This gallery shows some pictures of bad solderings - they should prevent you from making the same errors (feel free to add even more pictures here!)

Permanent link:
https://midibox.org/dokuwiki/doku.php?id=bad_solderings_gallery&rev=1160904901

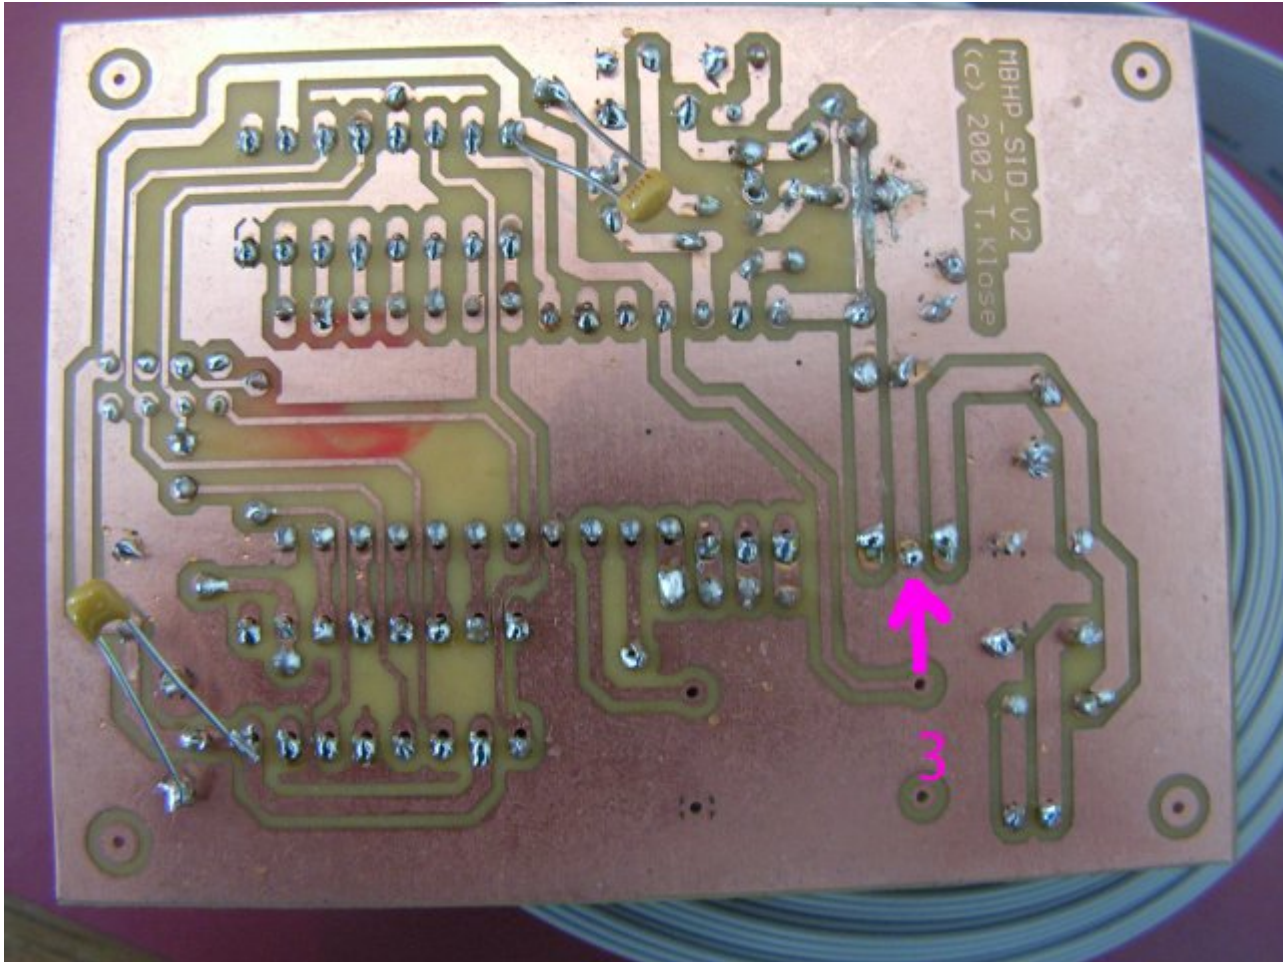
1: the core module has some bad solderings (loose connections), which could lead to failures. There are also missing solderings (e.g. 33pF cap below crystal). It makes sense to solder each pad again, the [Soldering](#) guide in the Wiki gives some useful tips

2: the legs of the caps should be cutted, otherwise they can cause a short circuit which can damage the PIC!

3: this seems to be a bad ground connection directly at the 78xx - it can lead to the wrong voltage. Here the same: just solder the pads again, it will help

And same like above: the long cap legs need to be cutted, the danger for shorts is too high!
